HOSHIZAKI AMERICA, INC.

SERVICE BULLETIN

SB20-0010R1

Subject: RST55C1E compressor protector change (4A4376-01)

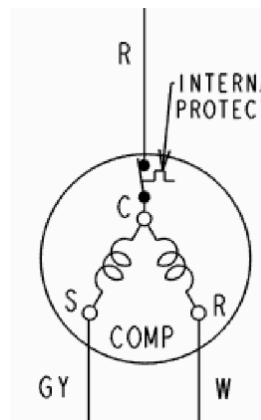
The compressor manufacture of the RST55C1E compressor will be changing their design from an external protector to an internal compressor.

As part of the change Hoshizaki will be changing the part number from 4A4376-01 (External protector) to 4A4376-02 (Internal protector). Part number 4A4376-01 and 4A1726-37 will sub to 4A4376-02 when inventory is depleted.

In the event you are replacing an externally protected compressor with an internally protected compressor simply eliminate the protector and wire the compressor as shown below.
